BRUNSWICK STEAM ELECTRIC PLANT, UNIT 2

Amendment No. 83
License No. DPR-62

ATTACHMENT TO LICENSE AMENDMENT NO. 83

SAFETY EVALUATION BY THE OFFICE OF NUCLEAR REACTOR REGULATION

FIGURE 3.2.3-1

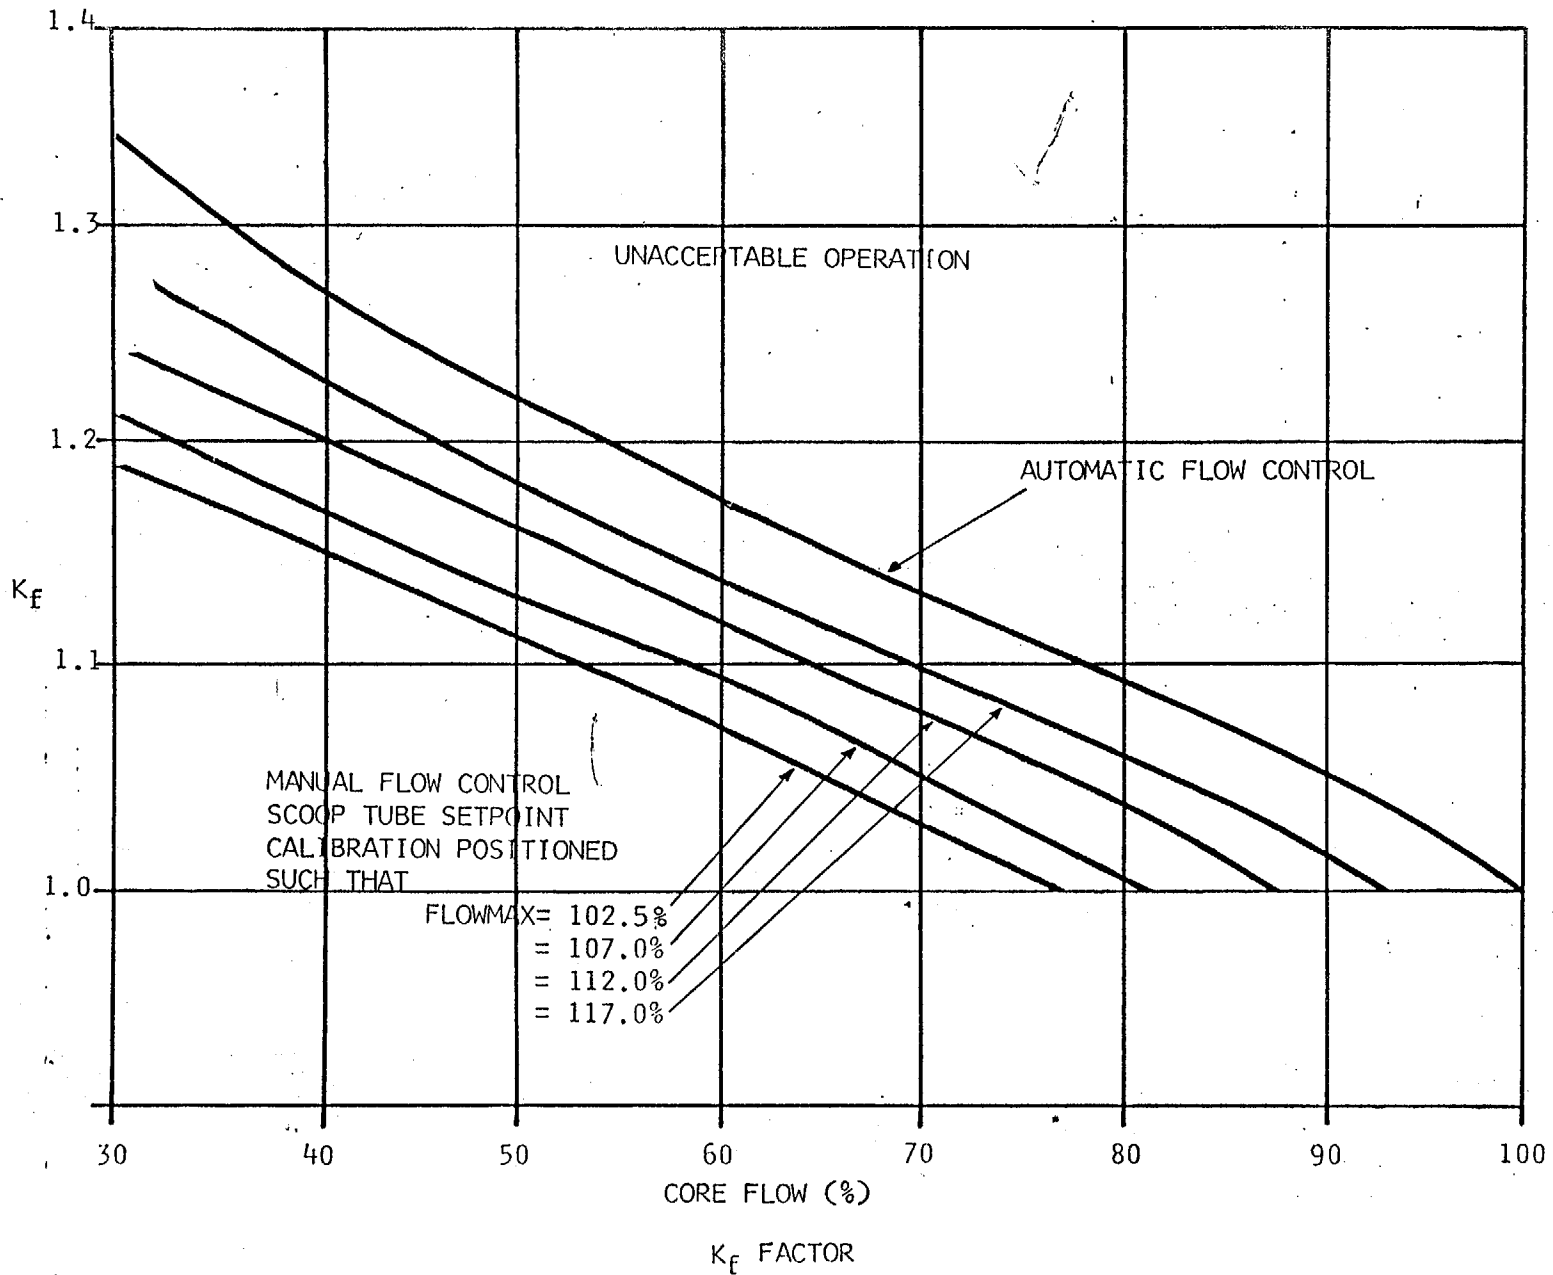
3.2.3.1 The MINIMUM CRITICAL POWER RATIO (MCPR), as a function of core flow, shall be equal to or greater than the MCPR limit times the K_f shown in Figure 3.2.3-1, provided that the end-of-cycle recirculation pump trip system is OPERABLE per specification 3.3.6.2, with:
